HOWARD COUNTY HISTORIC PRESERVATION COMMISSION
ELlicott City Historic District ■ LAWYERS HILL Historic District
3430 Court House Drive ■ Ellicott City, Maryland 21043

Agenda

Thursday, October 1, 2020; 7:00 p.m.

This Agenda identifies the work proposed and includes comments and recommendations from DPZ Staff. The recommendations included here do not constitute a decision of the Commission.

Figure 1 - Location of proposed fence shown with red line.

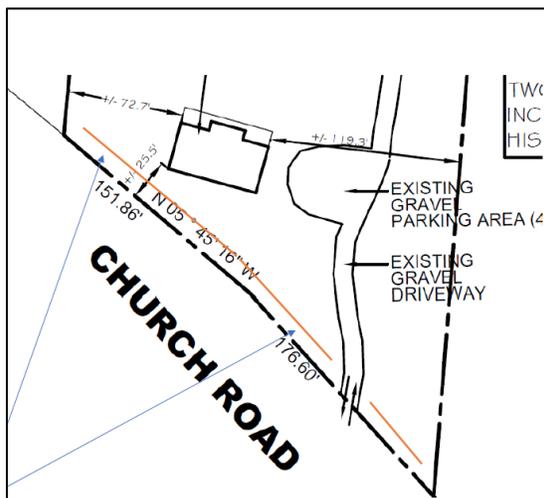
While the Guidelines state that split rail or post and rail fences are more appropriate in less densely developed areas such as upper Church Road, there are no other fences marking property lines in this

vicinity, except for the fence lower on Church Road around the Patapsco Female Institute. This would be the first fence in a front yard along upper Church Road.

The style of fencing complies with the Guidelines. The white color will match the siding on the house. Alternatively, a black fence would also match the house (which has black shutters, gutters and downspouts) and may blend into the environment more. Pressure treated posts would reduce the rot but paint does not adhere to treated wood as well as a good quality hardwood.

Staff Recommendation to the HPC: Staff recommends the HPC determine if the application complies with the Guidelines and approve or deny accordingly.

Figure 21 - Proposed site plan.

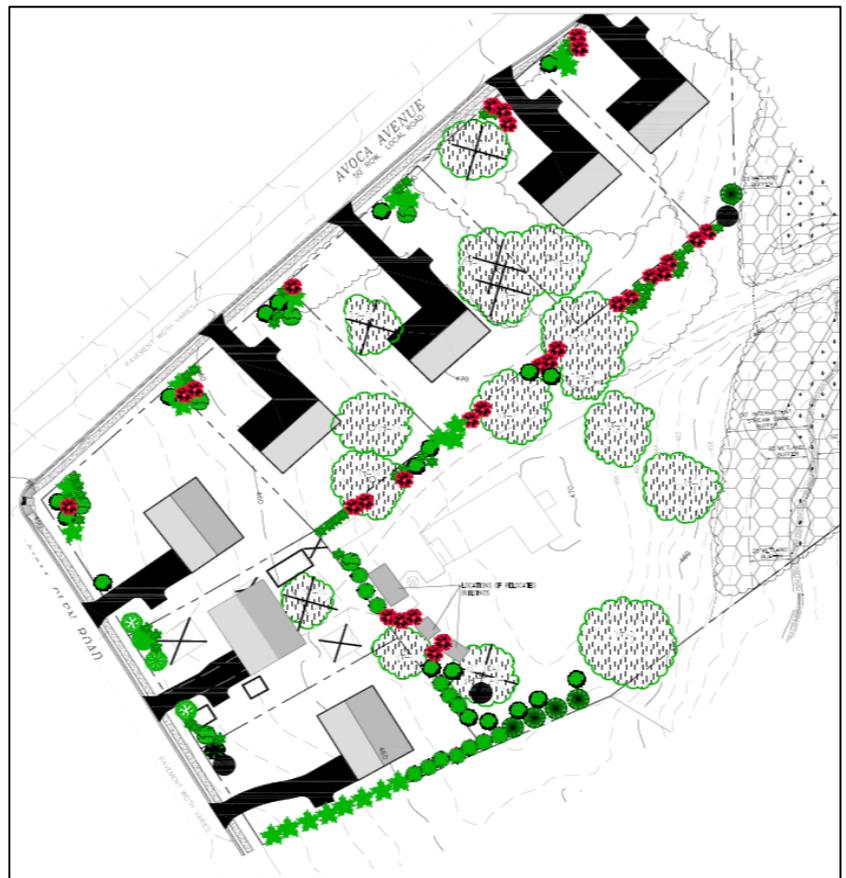
While the lot with the historic house will contain open space, the open space will not buffer the historic house from the new development. Instead, the historic house is proposed to be screened from the new development by a vegetated buffer on the lot with the historic house. Of the seven new homes proposed, three (Lots 2, 4 and 6) abut the 30' building restriction lines (BRL) found to the rear of the homes, all of which are adjacent to Lot 1. The HPC should consider whether the buffer is appropriate or if additional buffering is needed.

The original driveway from Montgomery Road is proposed to be maintained. The current rear access will be lost, as Lot 3 will be placed there. Retaining the existing driveway complies with the Guideline recommendations and will preserve the setting. However, according to the Department's Division of Land Development, because the original driveway is off Route 103, a minor arterial road, access is restricted and would be required to be off a lower classified road.

It is unknown if the property is being developed to its maximum density, however the removal or relocation of historic outbuildings located on Lot 3 will have an adverse effect on historic resources. The establishment of Lot 3 will also impact the ingress and egress for Lot 1. Should the existing rear driveway for Lot 1 be retained, the existing outbuildings would provide a more appropriate buffer from Lots 4 and 2 than an added vegetated buffer. Due to the condition of the historic outbuildings, they will

On the black and white site plan, the vegetated buffer is shown on each new lot. The engineers clarified that the buffer has been shifted to Lot 1, which will keep individual homeowners from removing the buffer. The current plan shows the tree and shrub buffer will be under the canopies of the Beech and Kentucky coffee-bean specimen trees. Digging large planting holes throughout the understory of the

trees will cause stress and potential harm to the historic trees, namely ST- 5, ST-6 and ST-7. An appropriate fence screening maybe be less disruptive in this area under the canopy closures.

Staff Recommendation to the HPC: Staff recommends the HPC provide advice on the design of the subdivision, in order to best protect the integrity of the historic house, historic outbuildings, and the setting, to include specimen trees.

Figure 24 - Historic outbuildings facing Knoll Glen Drive to be relocated. Currently located on proposed Lot 3.

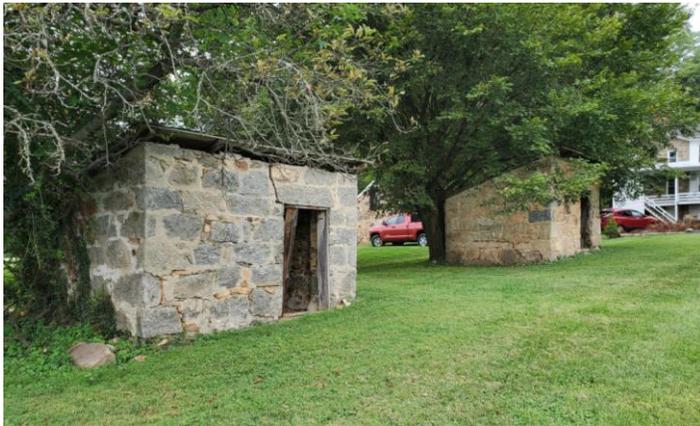
require extensive repair in the stonework before they can be moved. There is significant deterioration of mortar on all of the buildings, and it is unlikely they can be moved unharmed in their current condition.
